<b>XtremeAir GmbH, Harzstr.2, D-39444 Hecklingen</b> Tel: +49 39267 60999 0, Fax: +49 39267 60999 20 www.xtremeair.de info@xtremeair.de	Document No. <b>SB-2014-003</b>
		Issue: A.02
DOA-Nr.: EASA.21J.360	<b>Service Bulletin SB-2014-003</b>	Date: 01.09.2014

**Subject:** Right hand Exhaust brace

**Aircraft type affected:** XA41-XA42

Figure 2: Assembly exhaust brace XA42-7810-101

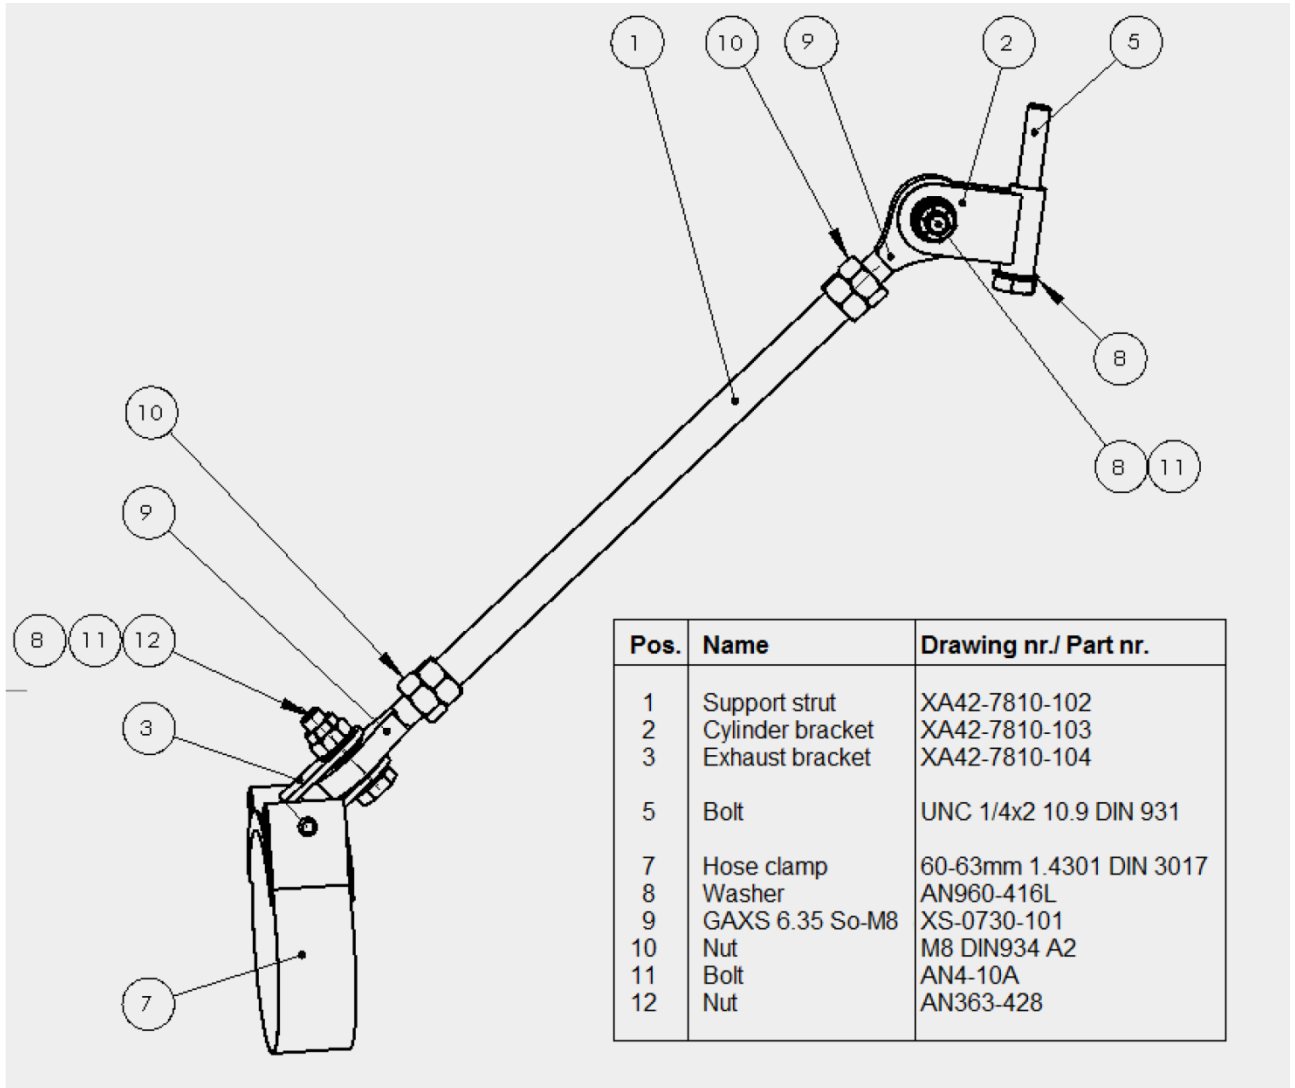
**Background:** On some aircraft the exhaust brace (XA42-7810-214) showed cracks. The new brace (XA42-7810-101) has a better resistance against cracks and is adjustable in length.

3. Install the new exhaust brace (XA42-7810-101) between the RH exhaust clamp and the no.5 cylinder as seen in Figure 1 right and in Figure 2.
4. Reinstall the cowling in reverse order.
